## FIELD OBSERVATION REPORT

West Hardin Middle School, 202280 -CA8

Report No: 25

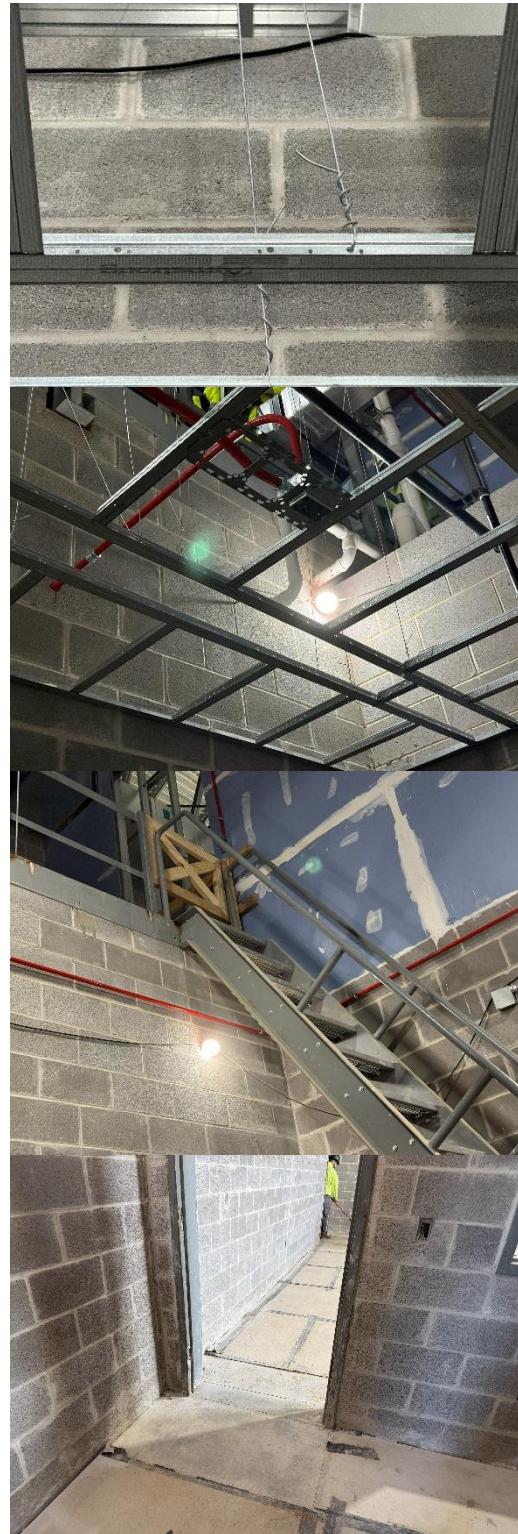
b) The ductwork installed above the wallboard ceiling was installed with manual dampers. These will not be accessible after the wallboard ceiling is installed. It was decided that the dampers will be secured in a fully open position and the air will be balanced with adjustable dampers in the ceiling mounted diffusers.

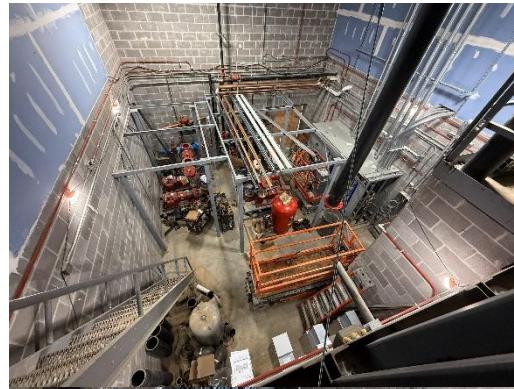
- v) Concrete block on the southernmost classroom wing was being laid up to eave height.

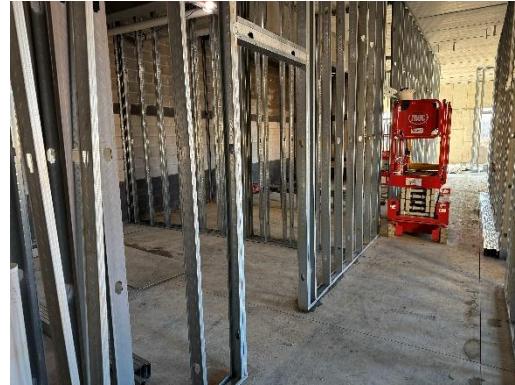
cc) Masons were preparing to lay concrete block in the southernmost classroom wing.
